Product Change Notification / GBNG-03JWKQ486

CCB 4443 Final Notice: Qualification of G631HQ mold compound material for selected Atmel AT32UC3Axxx and AT32UC3Cxxx device families available in 144L LQFP (20x20x1.4mm) package at ANAP assembly site.

**PRE AND POST CHANGE SUMMARY
CCB 4443**

QUALIFICATION REPORT SUMMARY

Pre Change

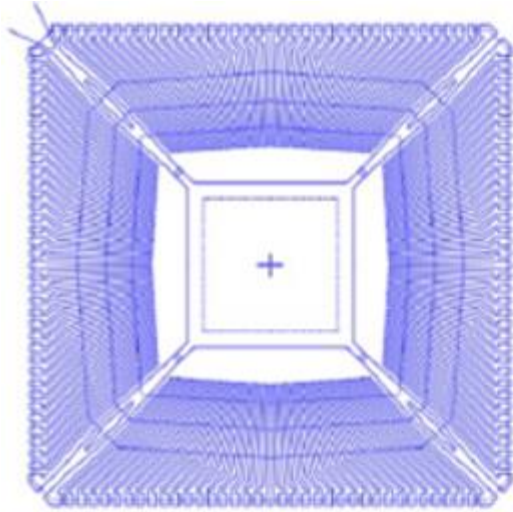
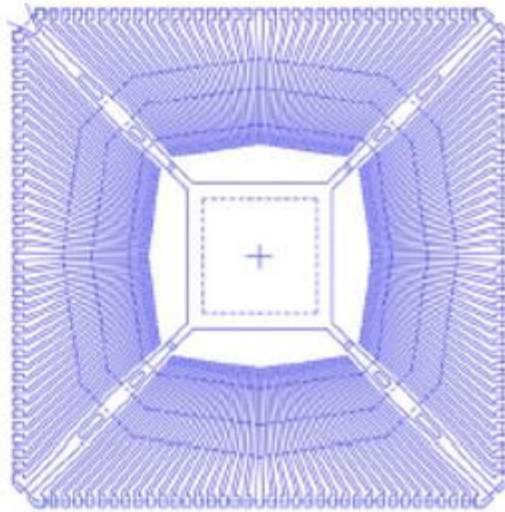
276x276 mils

236x236 mils

Strip Density	HDLF High Density Lead frame	HDLF High Density Lead frame
LF Paddle Size	276x276 mils	236x236 mils
DAP Surface Prep	Double Ring Ag	Double Ring Ag
Backside Dimple	Yes	Yes

Post Change

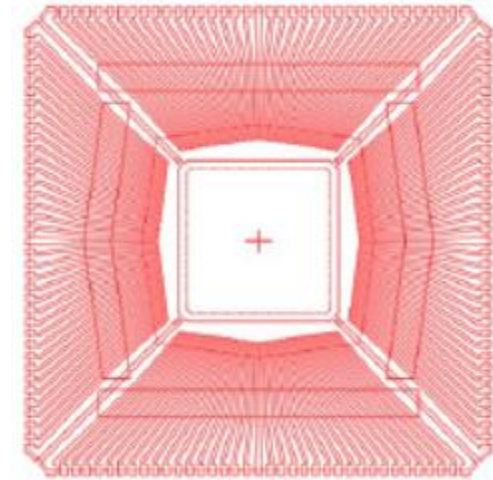
Strip Density	UDLF Ultra Density Lead frame
LF Paddle Size	276x276 mils
DAP Surface Prep	Double Ring Ag
Backside Dimple	No
